Design Review Commission Report

Meeting Date: Thursday, November 5, 2015
(continued from October 1, 2015)

Subject: **221 South Willaman Drive (PL1522650)**
A request for an R-1 Design Review Permit to allow the construction of a new two-story single-family residence located in the Central Area of the City south of Santa Monica Boulevard. The Commission will also consider adoption of a Categorical Exemption, pursuant to the California Environmental Quality Act.

EAST/ FRONT ELEVATION

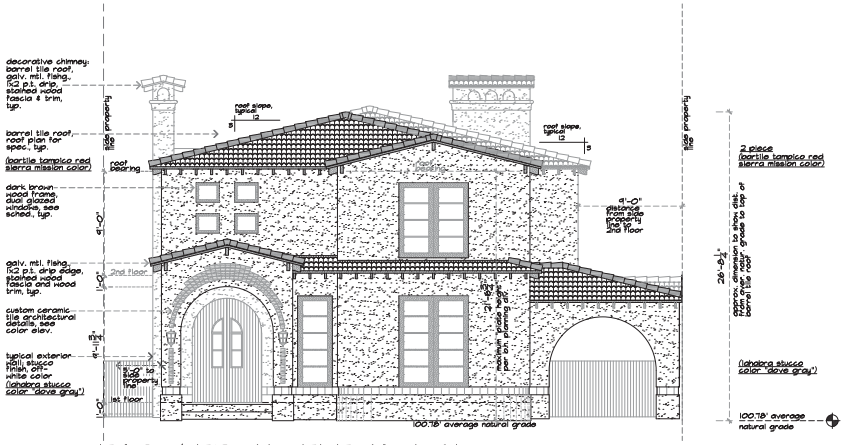
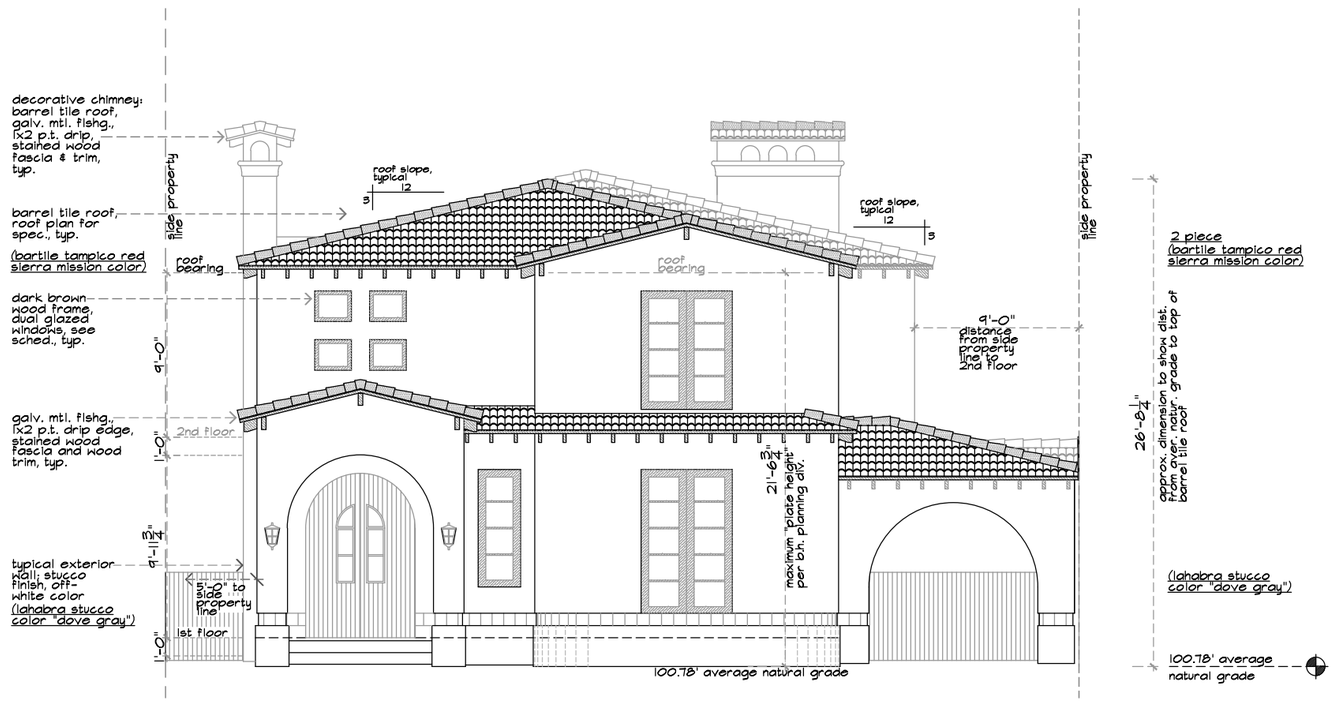
Based on a review conducted by the Urban Design Team, the proposed front door design appears disproportionate and too large for the façade and additionally the front door is shown as opening out rather than in so the front entry porch may need to be increased in depth. The windows on both the façade and the side elevations may benefit from some additional design details such as a bullnose detail or window sills or lintels. Staff feels that the design needs further refinement and is recommending that the Commission hold the public hearing and provide the Applicant with design guidance for the project.

Commission comment: front doors open out.
Response: front doors have been changed to swing in.

Commission comment: decorative tiles colors don't match.
Response: decorative tiles around entry arch have been removed, remaining tiles are changed to classic colors.

Commission comment: windows in front too large.
Response: the sizes of all front windows have been reduced.

- Revised the swing of the front door to swing in versus out;
- Revised the decorative tiles to classic colors and removed them from around the entry arch;
- Reduced the size of the large window of the stairway on the side elevation by one-third;
- Added a full wall on the side of the rear second floor balcony to prevent visual access to the neighbor;
- Reduced the size of the windows on the façade;
- Removed the front wall, pilasters and gates;
- Reduced the size of the windows on the side.

SOUTH/ L. SIDE ELEVATION

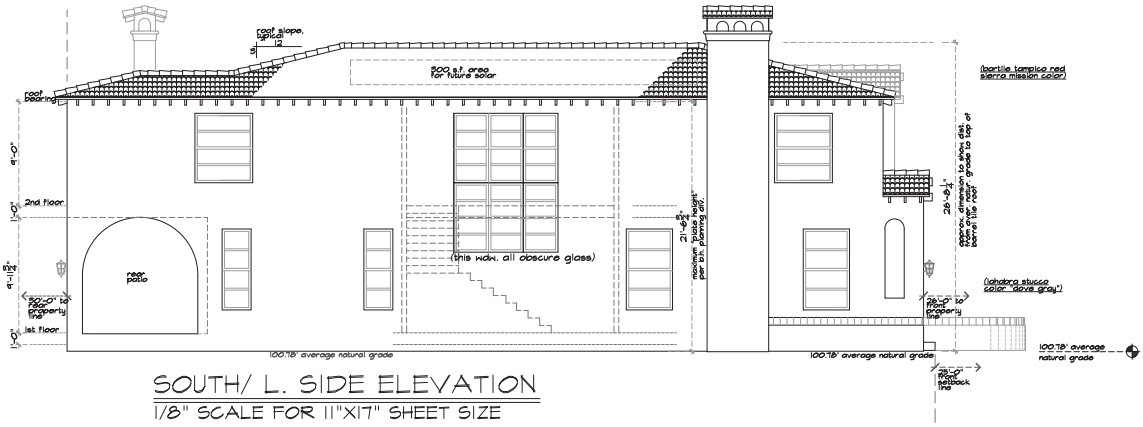
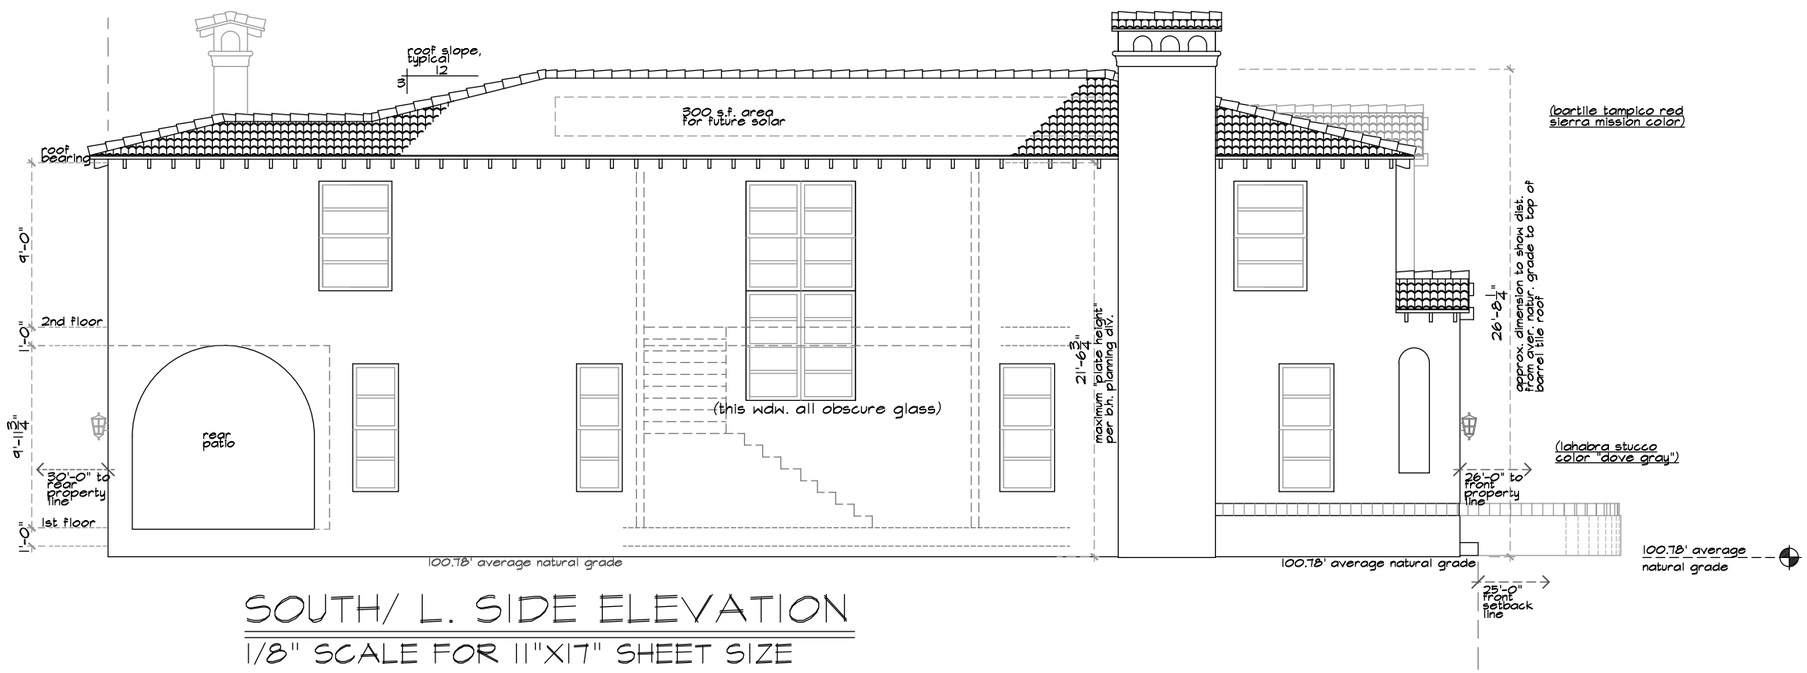
Commission comment: large window at side stairway too large.
Response: size of window at side stairway has been reduced in size by 1/3rd.

Commission comment: side windows too large.
Response: the size of almost all side windows has been reduced.

PROPOSED PLOT PLAN

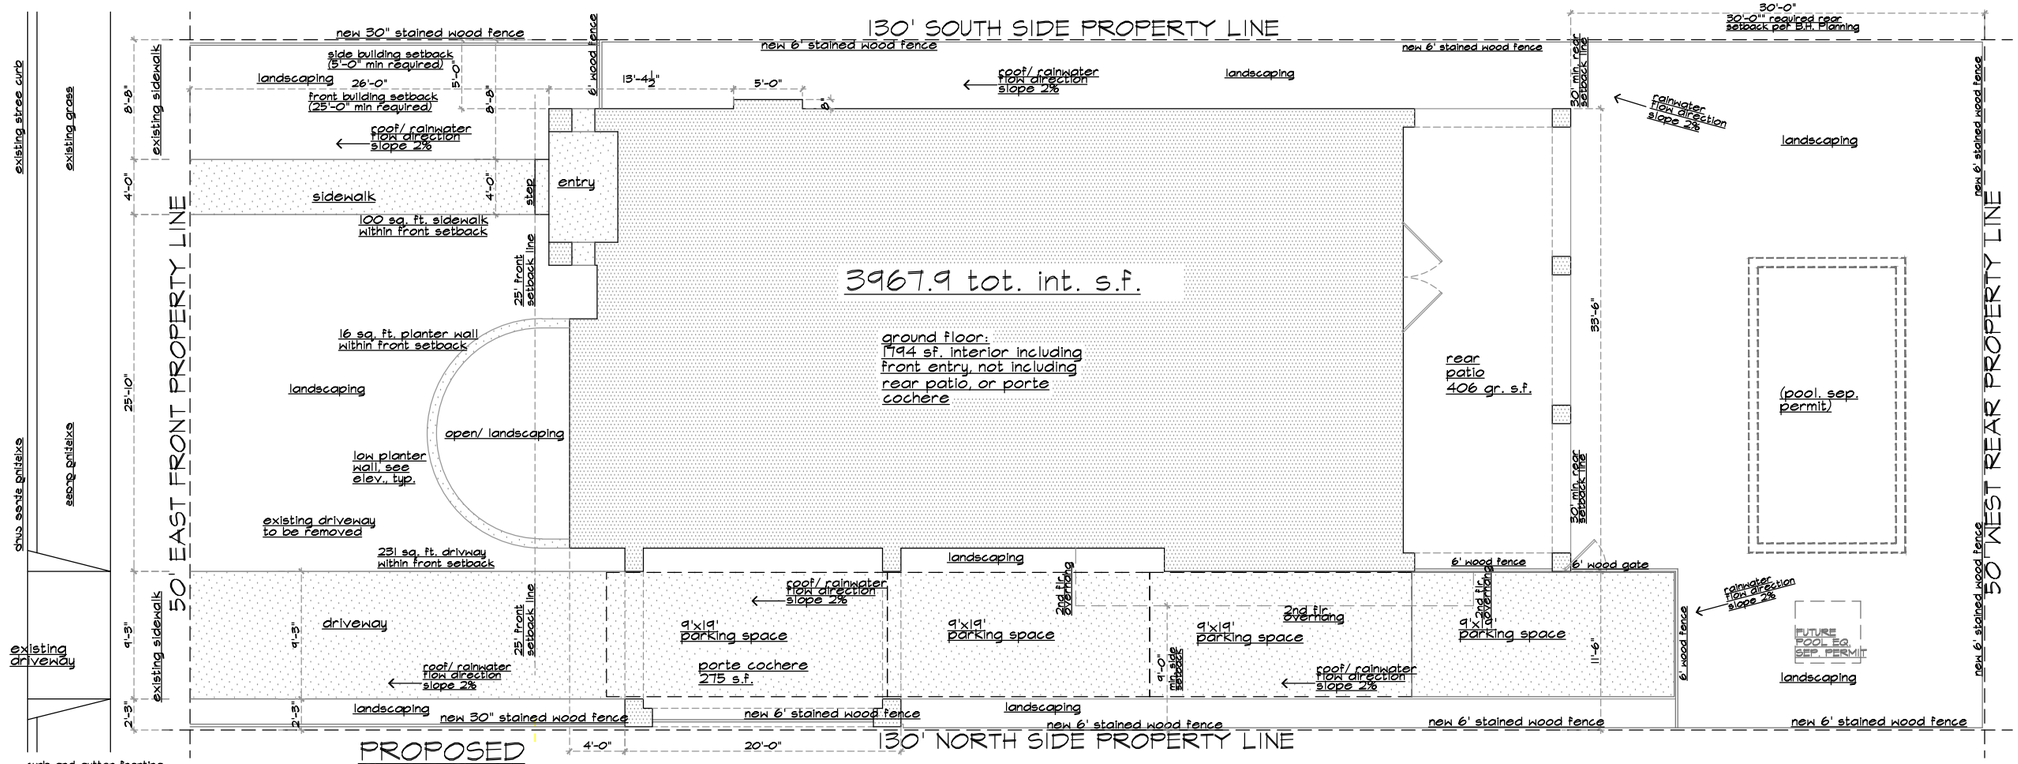
Commission comment: front pilasters, tiles, doesn't fit in.
Response: front wall with pilasters, tiles, and gates has been removed.

WEST/ REAR ELEVATION

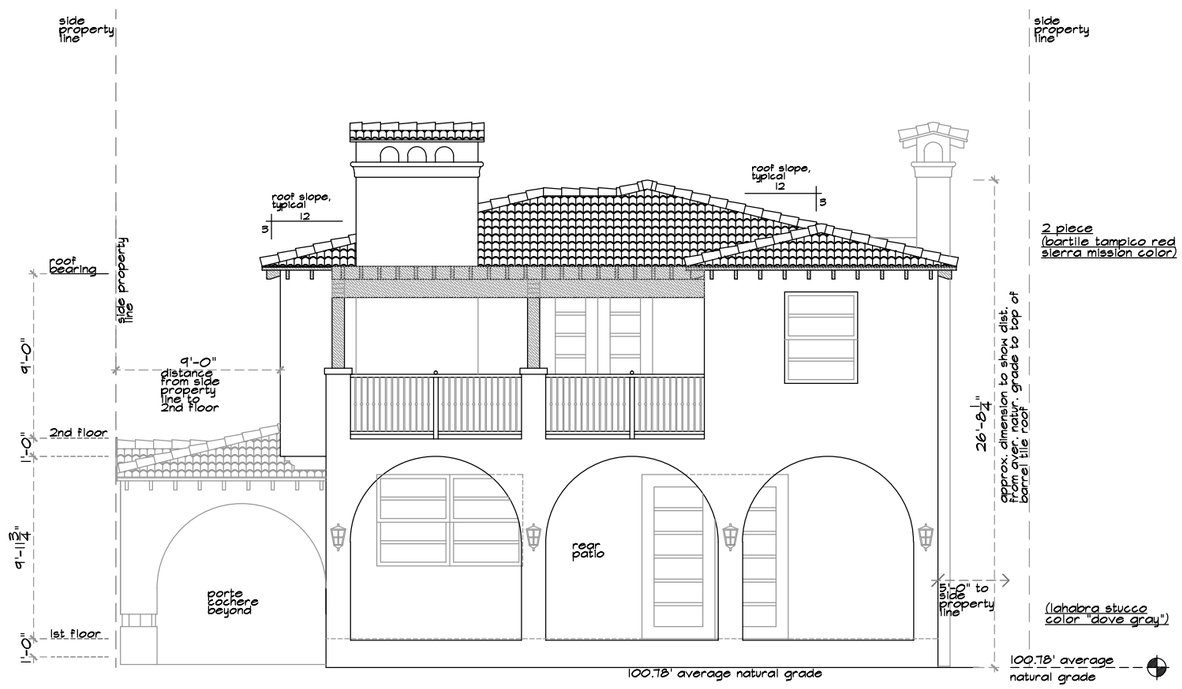
Commission comment: rear 2nd floor balcony looks over neighbor's property.
Response: full wall has been added at the side of the rear 2nd floor balcony.
